**GUNNISON COUNTY, COLORADO
COMMUNITY DEVELOPMENT DEPARTMENT, ENVIRONMENTAL
HEALTH OFFICE STAFF REPORT**

Proffitt

Application No: OWTS-21-00133
 Date application scheduled with EH Board: August 12, 2021
 Prepared by: Crystal Lambert, Building & EH Official

APPLICANT/OWNER:	Chandra and Jeremiah Proffitt
PROJECT DESCRIPTION:	The applicants are proposing a variance to permit a second OWTS on a single parcel to serve a proposed workshop building that will be an accessory structure to the existing dwelling on the parcel.
CURRENT STATUS OF OWTS APPLICATION:	The OWTS application was denied because <i>Section 3.A.10.</i> of the <i>Gunnison County OWTS Regulations</i> states that no more than one OWTS shall be permitted for an undivided parcel.
ENVIRONMENTAL HEALTH BOARD ACTION REQUESTED:	A request for a Public Hearing with the Environmental Health Board for the consideration of a variance to <i>Section 3.A.10</i> of the <i>Gunnison County OWTS Regulations</i> has been received and was prepared by Sara Bergstrom of SCJ Alliance Consulting Services
PROPERTY LOCATION:	14752 Highway 50
AREA DESCRIPTION:	The parcel is 171.194 acres and is approximately 30 miles southwest of Gunnison situated

SANITATION PLAN
SCALE: 1" = 30.0'

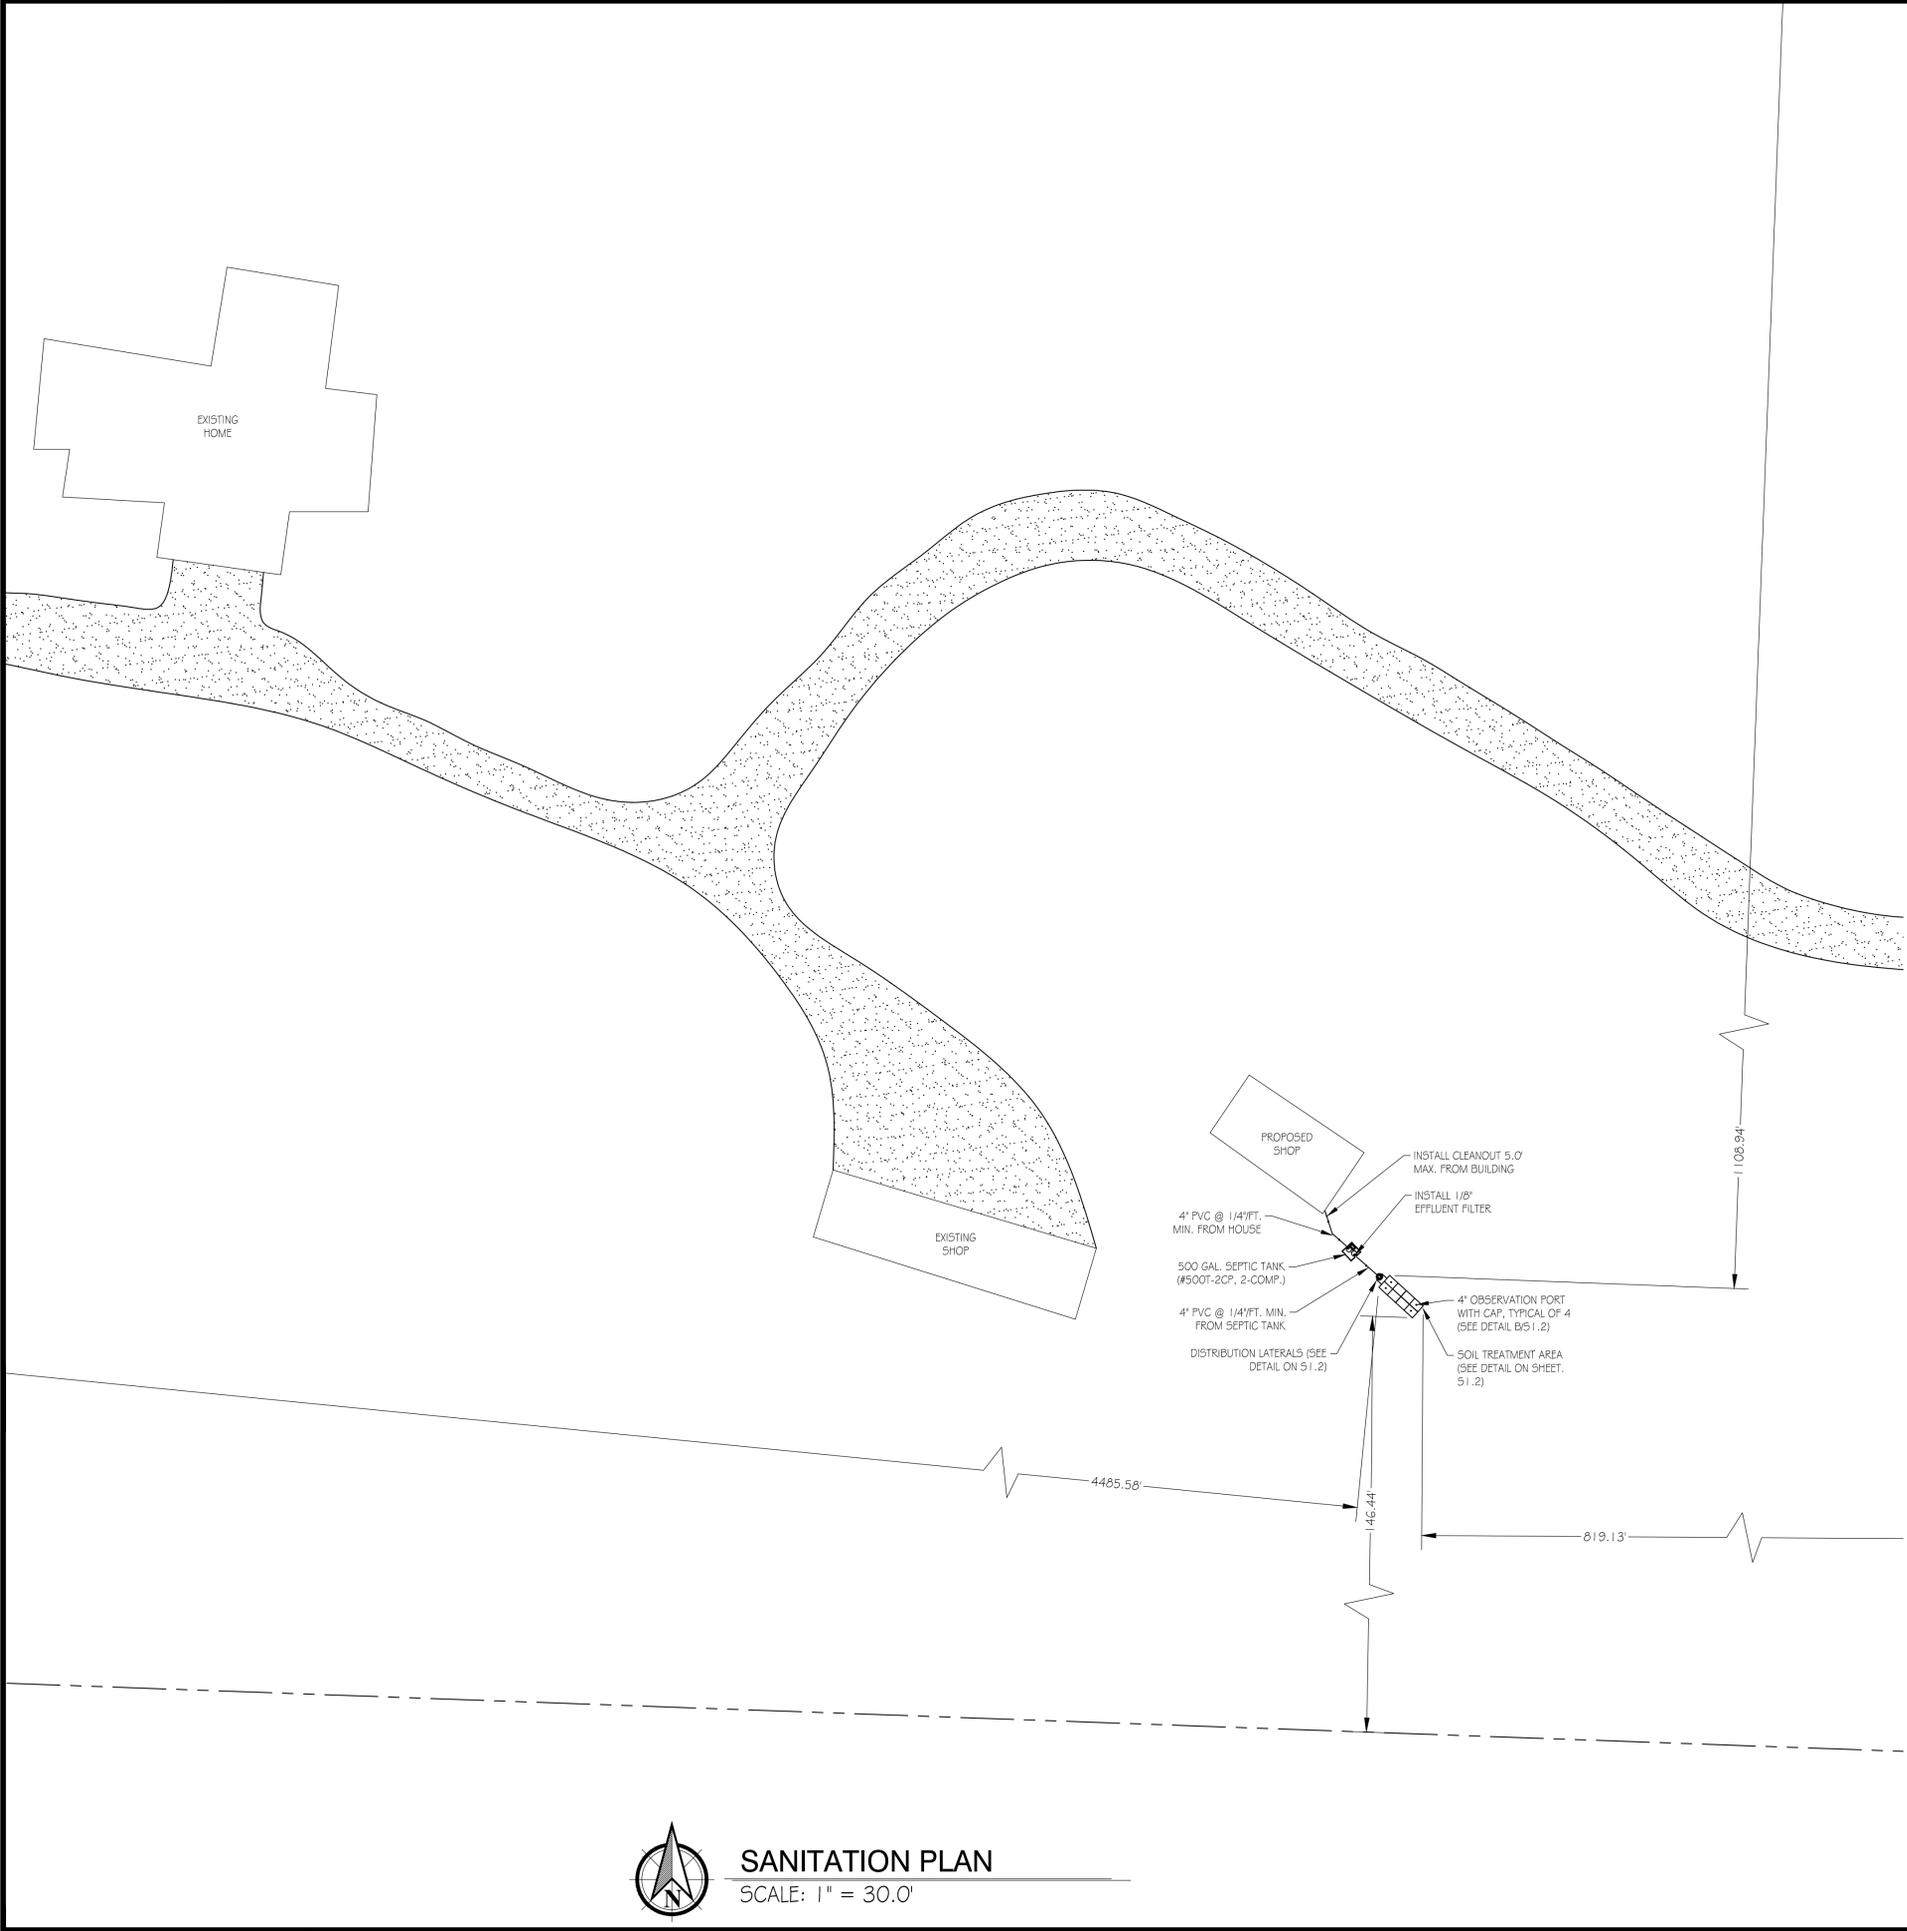
Variance Request Submittal Analysis		
Variance request submittals shall include the following items:	Applicant Submittal Summary	Staff Comments
<p>Site-specific request identifying the specific criteria from which a variance is being requested. Section 3.M.1.b(1)</p>	<p>The variance is being requested for a second OWTS to be installed on the referenced parcel.</p>	<p>Per Section 3.A.10 of the Gunnison County OWTS Regulations, no more than one OWTS shall be permitted for an undivided parcel. This is a local County requirement. The State of Colorado OWTS Regulations do not contain a requirement regarding number of systems per parcel.</p>
<p>Technical justification by a professional engineer or professional geologist, which indicates the specific conditions which exist and/or the measures which will be taken that support a finding that the</p>	<p>All the required setback distances between system components and waterbodies, wells, and pertinent physical features can be met. The existing septic system that serves the</p>	<p>All required horizontal setback distances to water bodies and pertinent physical features will be met. The existing system was installed in 1996 and serves the four-bedroom dwelling. The existing system is</p>

<p>variance shall result in no greater risk than that associated with compliance with the requirements of the OWTS Regulations. Section 3.M.1.b(2)</p>	<p>dwelling is over 500 feet away from the proposed workshop building. Connection to the existing system would require pumping and significant disturbance.</p>	<p>over 500 feet away from the proposed location.</p>
<p>A discussion of alternatives considered in lieu of the requested variance. Section 3.M.1.b.(3)</p>	<p>Connection to the existing system is not desirable and would require pumping and trenching over 500 feet.</p>	
<p>Technical documentation for selected alternative, which may include a testing program, which confirms that the variance does not increase the risk to public health and to the environment. Section 3.M.1.b.(4)</p>		<p>N/A-the applicant is not proposing an alternative system design. The proposed system meets the technical requirements of the OWTS Regulations.</p>

Prohibitions on the granting of variance requests:	Staff comments:
No variance shall be issued where the property can accommodate a conforming OWTS. Section 3.M.2.a.	The OWTS will conform to the technical and design requirements. The variance request is for a second OWTS on a parcel. If the variance request is approved, a proposed design will only be accepted for an OWTS permit if it meets the design requirements of the OWTS Regulations.
No variance shall be issued to mitigate an error in construction involving any element of property improvements. Section 3.M.2.b.	There is no known error of construction involving any element of the property improvements.
No variance shall be allowed on the grounds of cost of compliance. Section 3.M.2.c.	A claim of cost burden is not being made.
No variance shall be issued if it will result in a setback reduction to an offsite physical feature that does not conform to the minimum setbacks defined in Table 7-1 of this regulation without proof of compliance of Section 3.M.5. Section 3.M.2.d.	The minimum setbacks to off-site physical features appear to be met with the proposed development plan.

No variance shall be issued if it reduces the separation to ground water or bedrock based on the level of treatment in Table 7-2. Section 3.M.2.e.	Required separations to groundwater and bedrock will be made.
No variance from the horizontal setback from a well shall be issued unless it also meets the variance requirements of the Board of Examiners of Water Well Construction and Pump Installation Contractors. Section 3.M.2.f.	The minimum required setback distances to wells will be met. The proposed system is approximately 200 feet away from the spring cistern.
No variance shall be issued for the installation of a higher level treatment system based on sizing or separation reductions without the Department having a maintenance and oversight program. Section 3.M.2.g.	A higher level treatment system is not proposed.

It appears that the proposed OWTS design meets the design criteria and setback distance requirements of the Gunnison County OWTS Regulations. Connecting to the existing system, which serves the existing dwelling, would require pumping and 500 feet of trenching. Staff recommends approval of the applicant's proposal which requires a variance to the Gunnison County OWTS Regulations, Section 3.A.10, for a second OWTS on a parcel to serve a future residence.
